UNITED STATES PATENT AND TRADEMARK OFFICE

APPLICATION NO.	FILING DATE	FIRST NAMED INVENTOR	ATTORNEY DOCKET NO.	CONFIRMATION NO.
10/714,367	11/14/2003	Gary J. Craw	18695-9318-00	1861
23409	7590	04/04/2006		EXAMINER
MICHAEL BEST & FRIEDRICH, LLP 100 E WISCONSIN AVENUE MILWAUKEE, WI 53202			HAN, JASON	
			ART UNIT	PAPER NUMBER
			2875

Office Action Summary	Application No.	Applicant(s)
	10/714,367	CRAW ET AL. <i>(initials)</i>
	Examiner Jason M. Han	Art Unit 2875

DETAILED ACTION

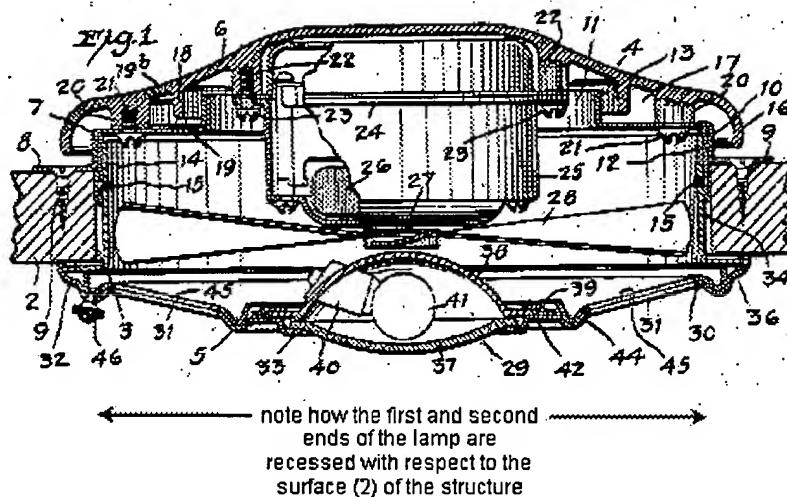
11. With regards to Claim 8, Roethel discloses the lamp [Figure 1: (40, 41)] having a first end and a second end, whereby the first and second ends of the lamp both are recessed with respect to the surface of the structure [see drawing below].
